SAFETY RECALL CODE 0811 - S1 AND S1W NEGATIVE BATTERY CABLE

Buell Motorcycle Company has learned that certain 1996-1998 Buell motorcycles were built with a negative battery cable that could break. This condition could cause the engine to stall/quit when riding. Accordingly, Buell Motorcycle Company is conducting a voluntary recall campaign to formally recall all potentially affected motorcycles.

This campaign involves all 1996-1998 S1 Lightning and all 1998 S1 White Lightning model Buell motorcycles manufactured between January 20, 1996 and June 16, 1998.

Figure 2. Negative Battery Cable

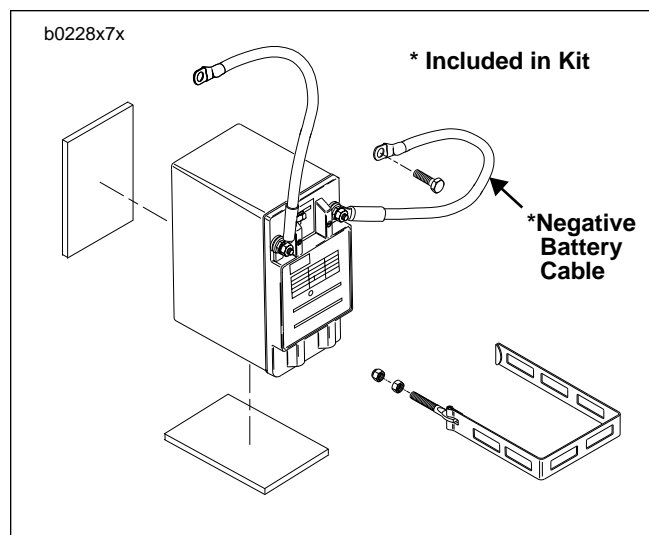
1. Visually inspect the negative battery cable coming from the left (-) side of the battery. Inspect for the following:
 - HD Part Number 70461-67B and lot number printed on cable.
 - Shiny heat shrink on both ends
 - Silver-colored soldered wires visible at the terminals

If the cable on the motorcycle being inspected meets the above criteria, replace the cable with the new cable provided in the kit. See *INSTALLATION* below.

If the cable on the motorcycle being inspected has gold wires at the connector and Buell Part No. Y0321.9A on it, it is equipped with the correct cable and this service does not need to be performed.

10. See Figure 2. Disconnect negative (-) battery cable from battery terminal.
11. Disconnect negative (-) battery cable from frame. Remove and discard original negative (-) battery cable.
12. Install **new** negative battery cable supplied with kit to frame with existing hardware. Tighten bolt to 10 ft-lbs (13.6 Nm). Use care when routing cable to avoid contact between cable and circuit breaker.
13. Install **new** negative battery cable supplied with kit to negative (-) battery terminal with existing hardware. Tighten battery cable bolt to 30-40 **in-lbs** (40.7-54.2 Nm).
14. Install tail section with two TORX bolts and nylon washers. Tighten TORX bolts to 72-96 **in-lbs** (8.1-10.8 Nm).
15. See Figure 1. Install **new** hose clamp to fuel hose and fuel supply valve.
16. Install vent hose to fuel tank vent with cable tie supplied in kit.
17. Install fuel tank.
